# Block 1, Central Park Foster + Partners

**PPR Submission Report  
Central Park Block 1  
State Significant  
Development Application  
SSD14\_6554**

Frasers Property Australia  
(Central Park JV No.2)  
Central Park Precinct •  
January 2015 A-SK-1029

**Revised typical apartment floor layout**  
Comparison of SSDA Scheme with revised PPR Scheme

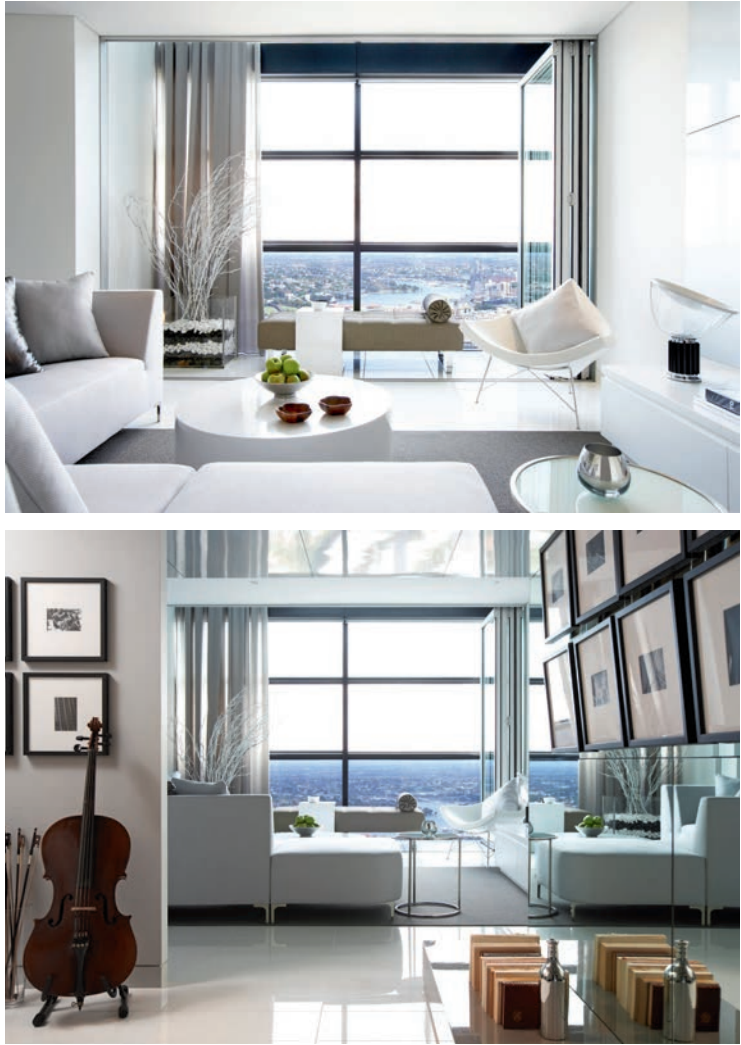
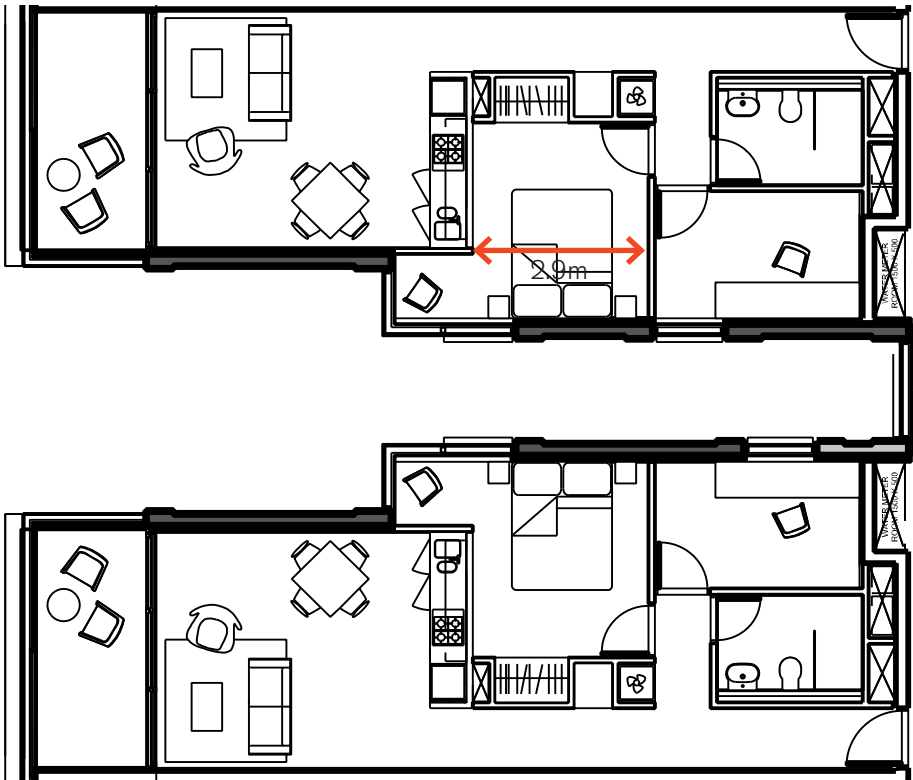
The diagrams on these pages highlight the apartments which have been revised. These are further explained on the following pages in annotated detail plans of the respective apartment typologies.

Revised proposal in PPR for Block 1

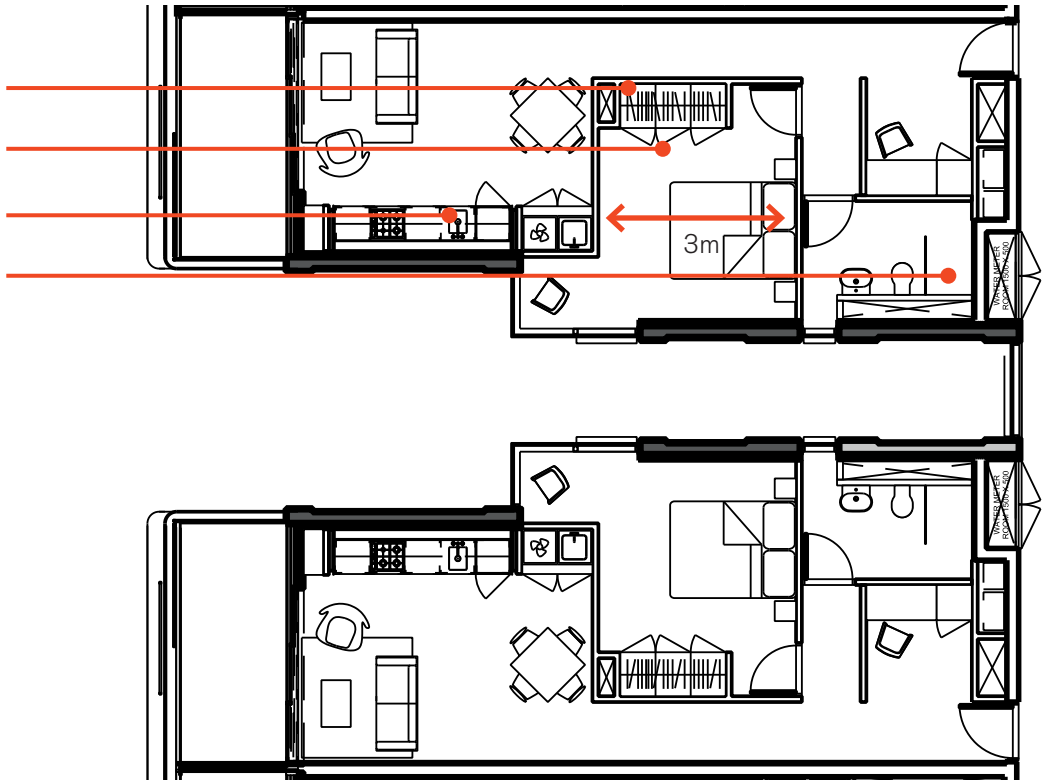
- 1. Improved size of wardrobe.
- 2. Improved size of bedroom.
- 3. Kitchen layout revised to accommodate laundry space and provide a more open living area.
- 4. Study/store and bathroom have been reconfigured to allow daylight in to bathroom. The revised location of the study/store allows for greater flexibility of use. The revised layout reflects the concerns raised by council preferring daylight to a bathroom and a reduced storage/study area.

Revised proposal in PPR for Block 1

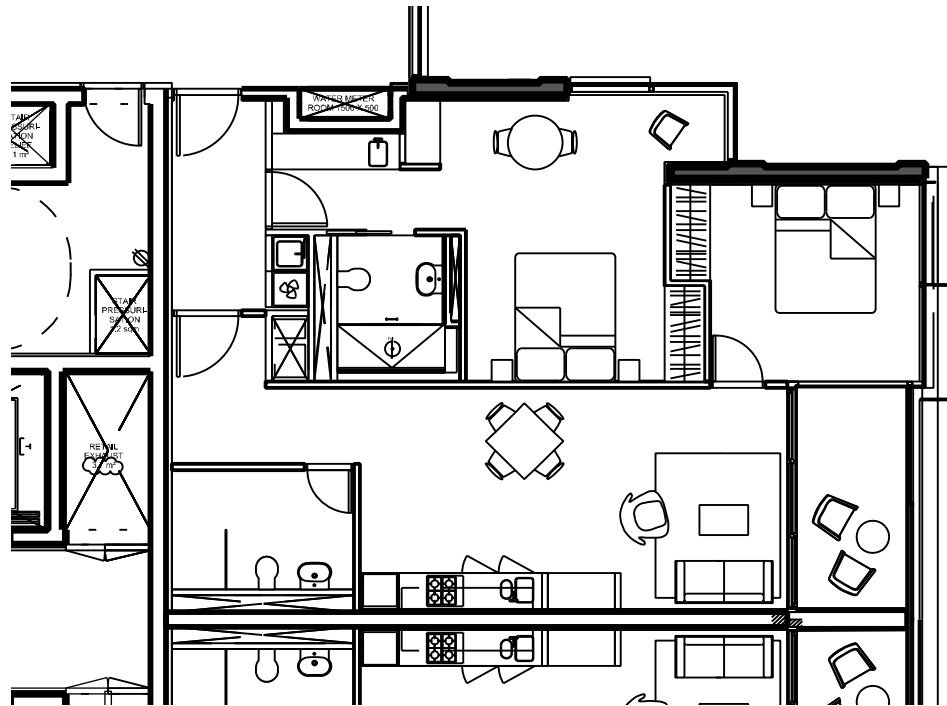
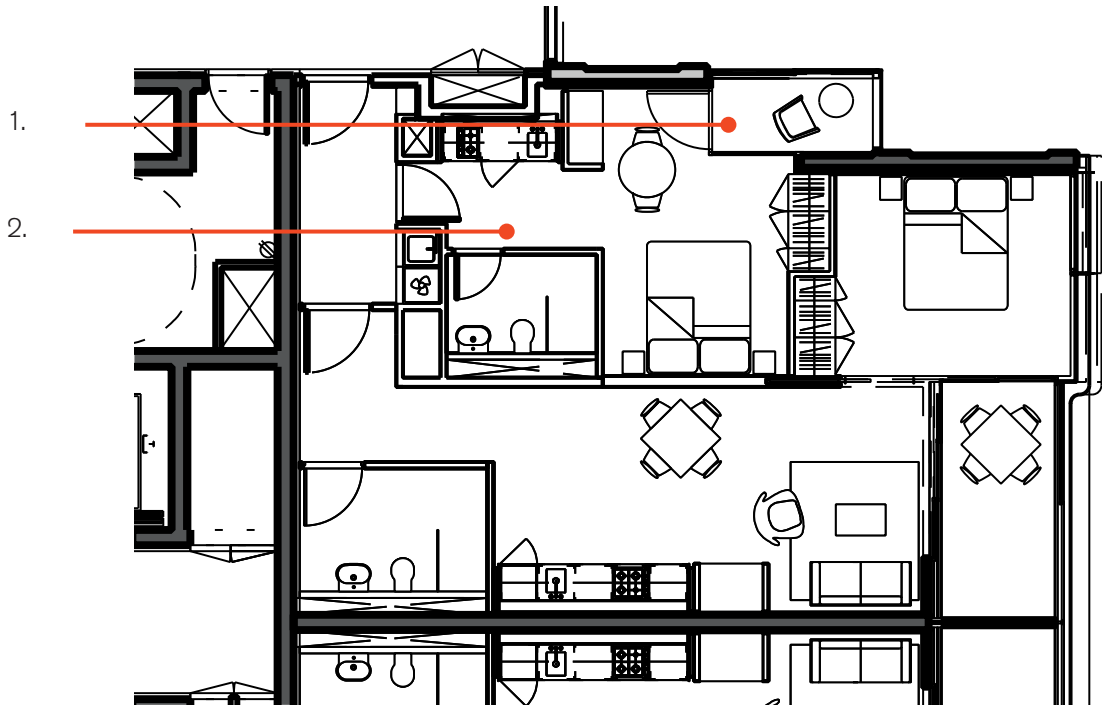
- 1. Loggia added to second key of 2-key apartment layout to provide private amenity space. This does not affect the overall size of the apartment. Apartment area remains the same.
- 2. Bathroom and kitchen layout amended to simplify layout and further define spaces within apartment.

Revised proposal in PPR for Block 1

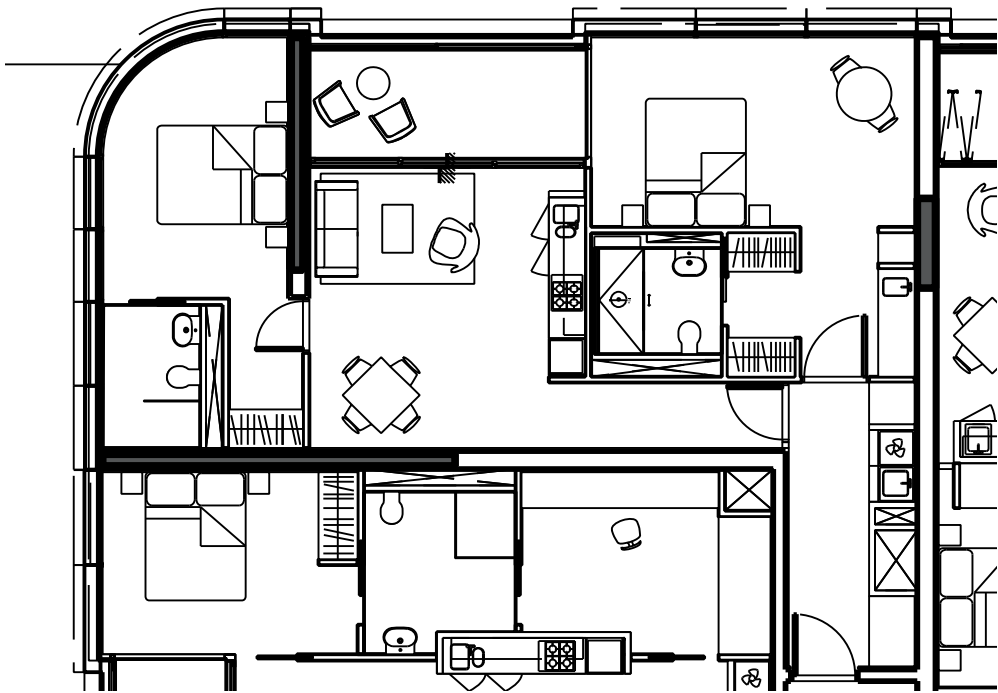
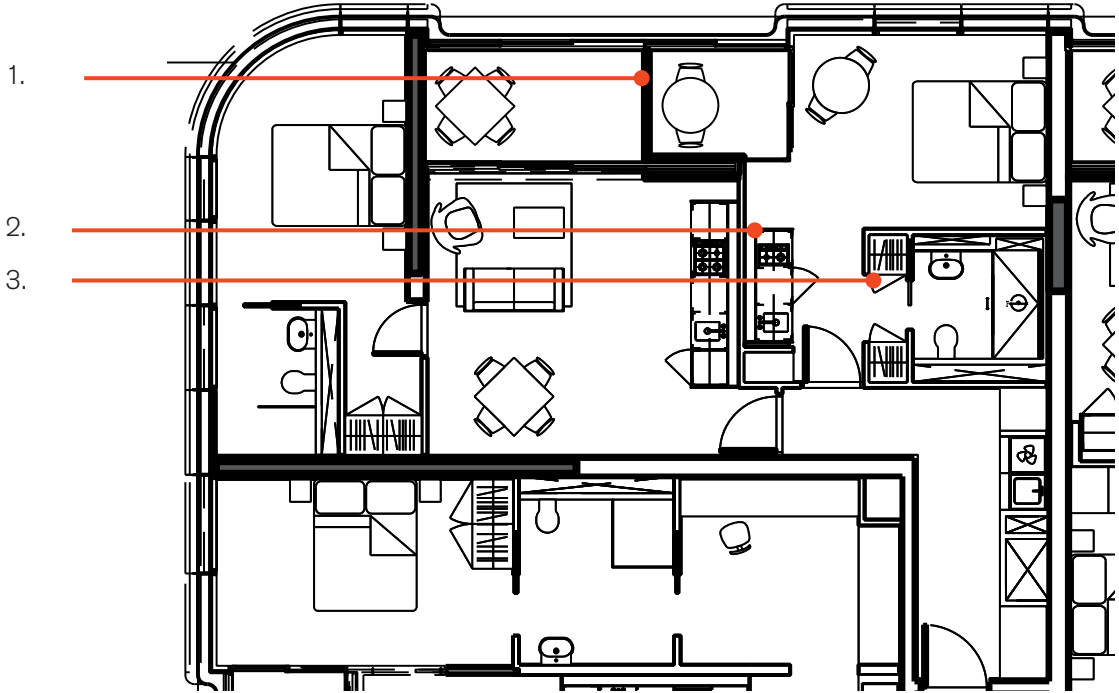
- 1. Loggia design revised to allow for 2-key unit to have private amenity space. Inter-tenancy wall to provide acoustic separation. This does not affect the overall area of the combined apartment however the smaller second key is increased slightly while the main apartment is reduced slightly by the same amount of approximately 4sqm.
- 2. Layout of kitchen unit and bathroom revised to work with reconfigured loggia.
- 3. Storage space within apartment has been reconfigured.

Revised proposal in PPR for Block 1

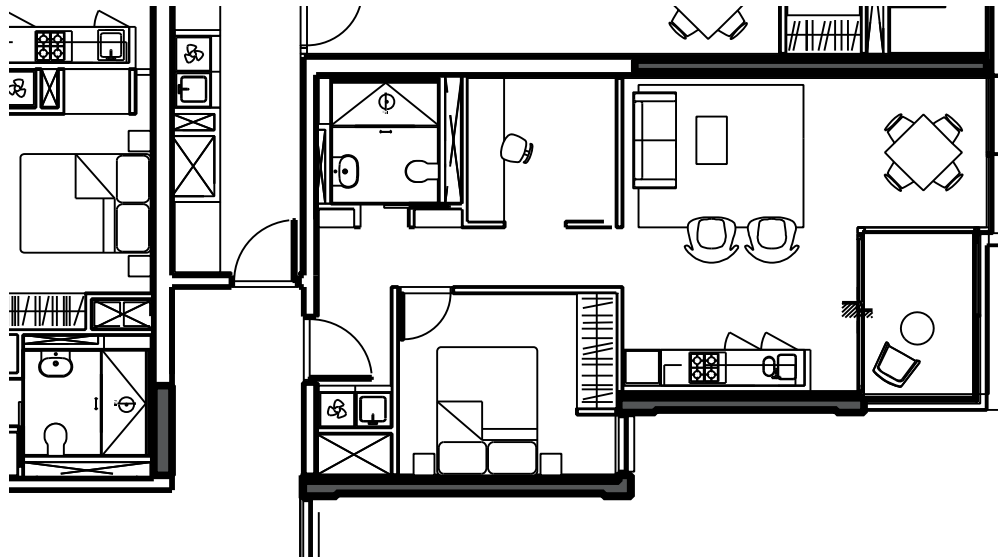
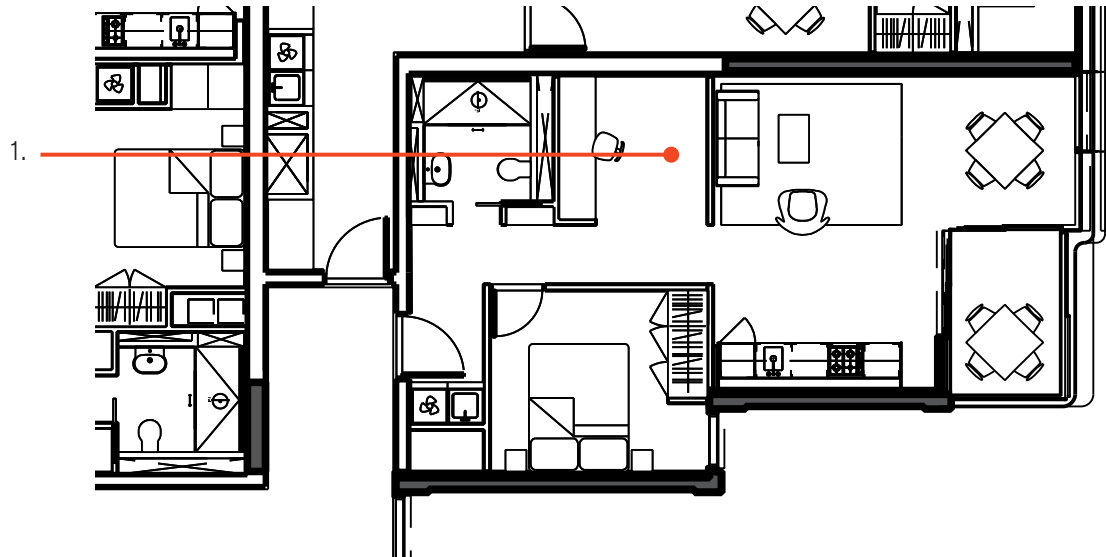
1. The study/store area has been revised to remove a wall and be more open in layout. This will then allow the space to be more easily integrated into the main living area if required.
